## ADDENDUM to UH-1-12-AMAM-04 COLLECTIVE LEVER

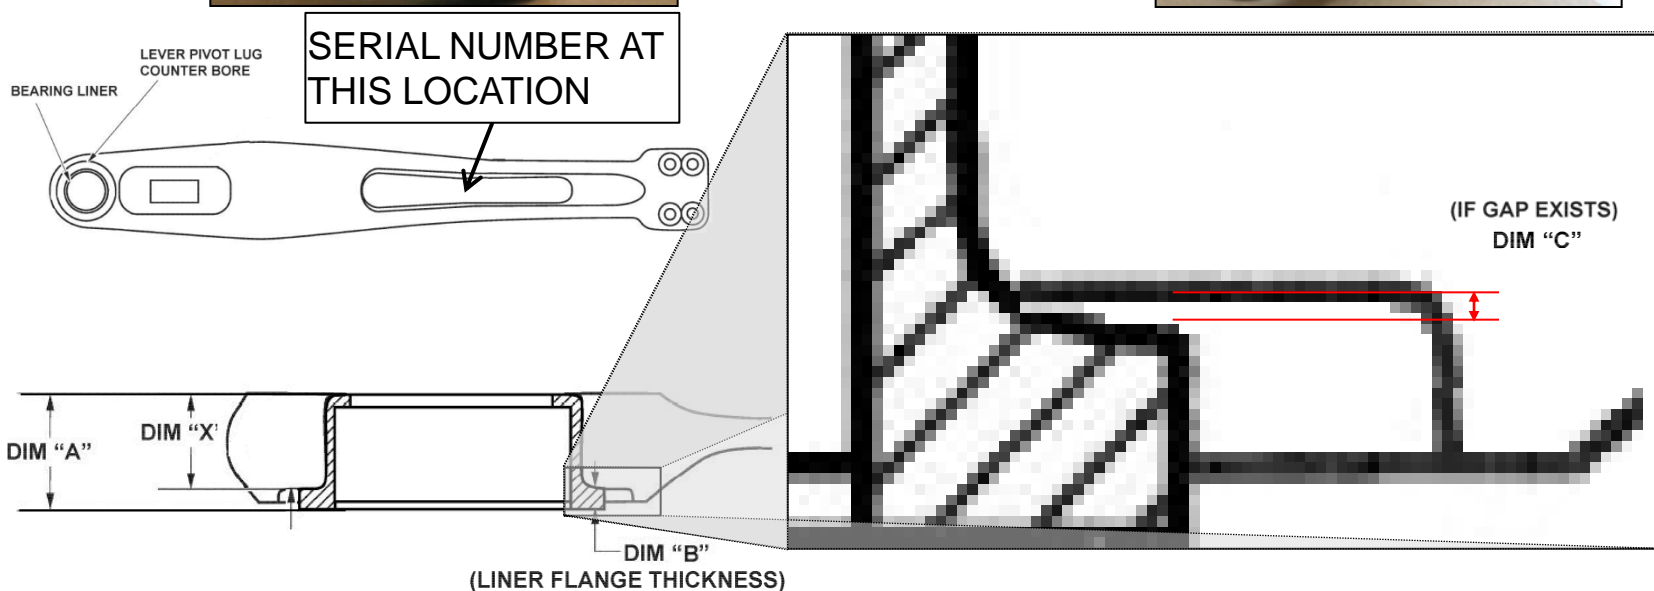
1. Dimension "X" is the lever pivot lug thickness at the counter bore. Minimum acceptable thickness is 0.450 inch (11.43 mm).
2. Dimension "A" is the measure between liner flange and inboard face of lever pivot lug.
3. Dimension "B" is the liner flange thickness. Use 0.060 inch (1.524 mm) for dimension "B".
4. Dimension "C" is the gap between the liner flange and the lever counter bore. Most likely no gap will exist.

**Lug thickness at counter bore "X" = "A" - ("B" + "C")**
